Addendum To Arboricultural Impact Assessment

Gloucester Lodge, Gloucester Gate, Regents Park,
London, NW1 4HA

Iconic Properties Limited

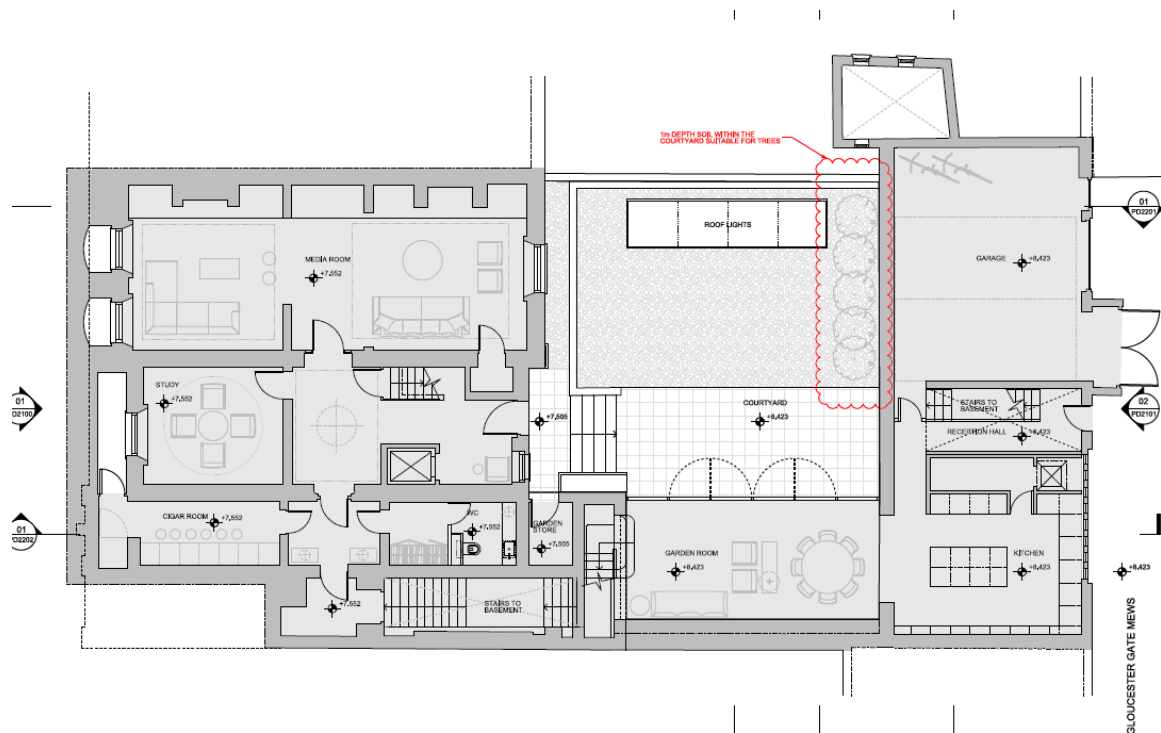
- 2.1 Following correspondence between the client and the LPA, a comment has been received about the impact of the rear basement and the removal of the pleached Hornbeam hedge (see below)

- 2.2 The removal of this hedge is shown on the extract below from the Tree Protection Plan as TG1 (shown in red for removal)

- 2.4 TG1 is a recently planted feature, with little visual amenity (as it can only be viewed from the rear of a small number of properties). Its removal would have no impact upon the streetscene, and would be unnoticed by the majority of people.

- 2.5 The rear basement does provide for boundary landscape treatments, and it would be very easy to replace the pleached trees once the basement was completed. These are commonly available as 'extra heavy' standards or even semi-mature trees, and once planted would immediately replace the screen.

- 2.6 A revised landscape proposal has been produced (Ref PD199) which shows an alternative location for a replacement Hornbeam hedge to directly replace TG1. The soil depth is sufficient at this location to establish and sustain the hedge during its life-expectancy. An extract showing this alternative location (highlighted in red) is shown below;
